**7000 Acres**

**7000 Acres Response to the Cottam Solar Project Ltd Application on the subject of:**

**Flooding Concerns**

Deadline 1 Submission – 17<sup>th</sup> October 2023

*Figure 1 - Area to the South East of Sturton By Stow towards Bransby & Broxholm*

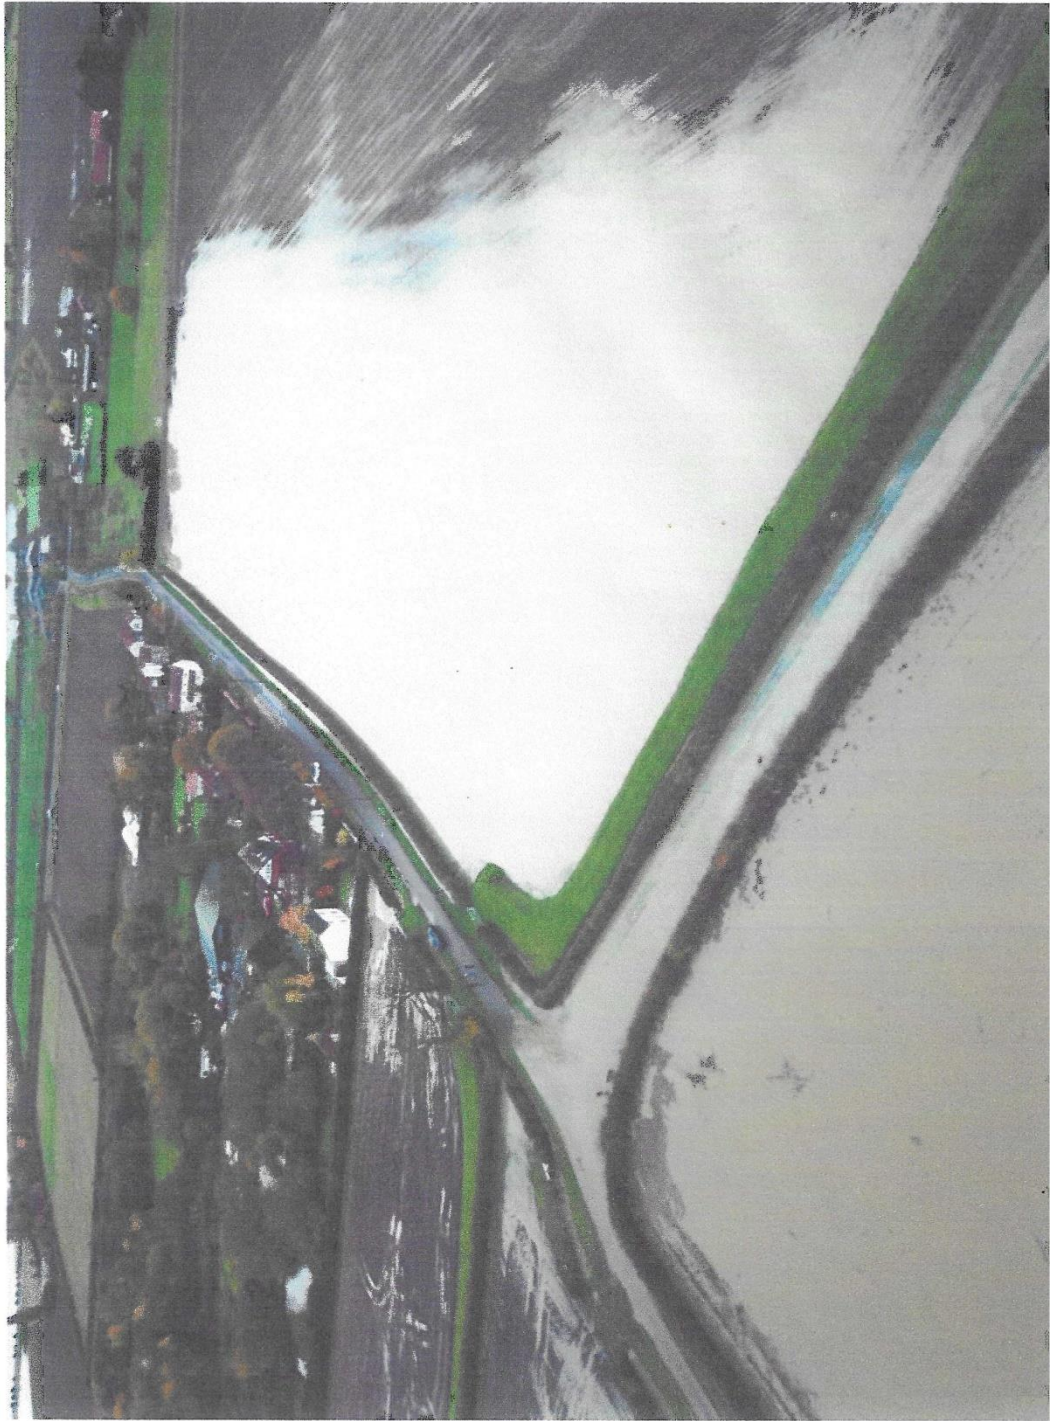
Photographs of the flooding of the area around the proposed site of Cottam 1 which occurred in November 2019 are hereby attached.
